Nine Mile Point Nuclear Station, Unit 1
Renewed Facility Operating License No. DPR-63
NRC Docket No. 50-220

Subject: Supplement No. 2 - Changes to the Nine Mile Point Nuclear Station, Unit 1,
Subsequent License Renewal Application

**Changes to the Nine Mile Point Nuclear Station, Unit 1,
Subsequent License Renewal Application
Supplement 2**

Figure – Feedwater Nozzle RPV Startup Transient 4/9/2021 to 4/11/2021 Temperature Data

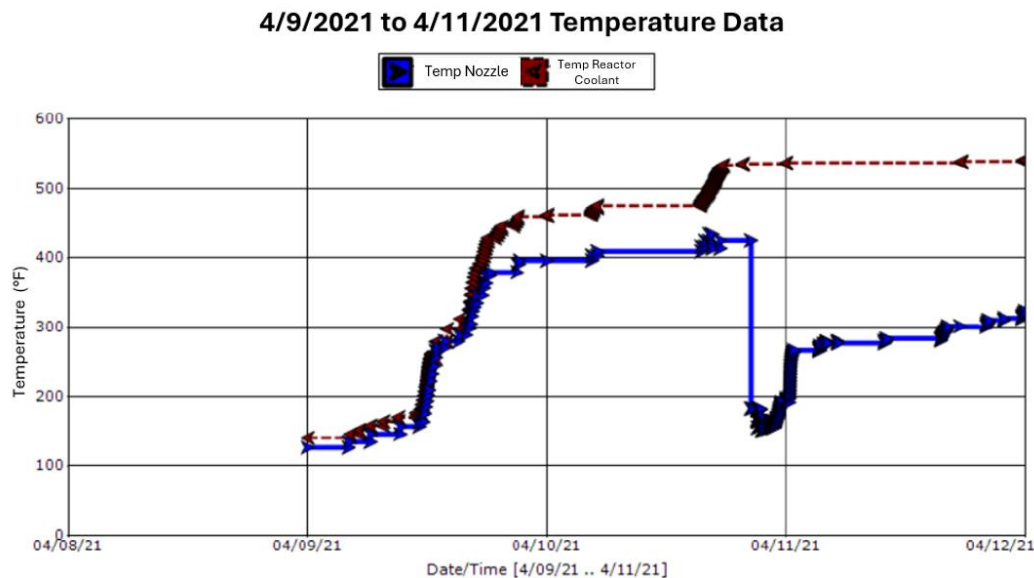
SLRA Section 4.3.5 is being revised to provide clarification on the average temperature approach. Confirmation of the conservatism of the average temperature approach is provided by a NMP1 specific demonstration that evaluated a transient for the feedwater nozzles using the average temperature approach and the modified rate approach. The transient occurred at NMP1 in April 2021, during an RPV startup from a refueling outage. As shown in the figure below, the feedwater nozzle heats up with the reactor and comes back down in temperature with increasing feedwater flow and then back up with feedwater heating. This actual (plant data) transient is a complex thermal transient. Note, the blue line in this figure shows the temperature trend for the feedwater nozzle while the brown line shows the reactor temperature.

In addition, SLRA Section 4.7.3 is being revised to clarify feedwater nozzle blend radius and safe end inspection results.
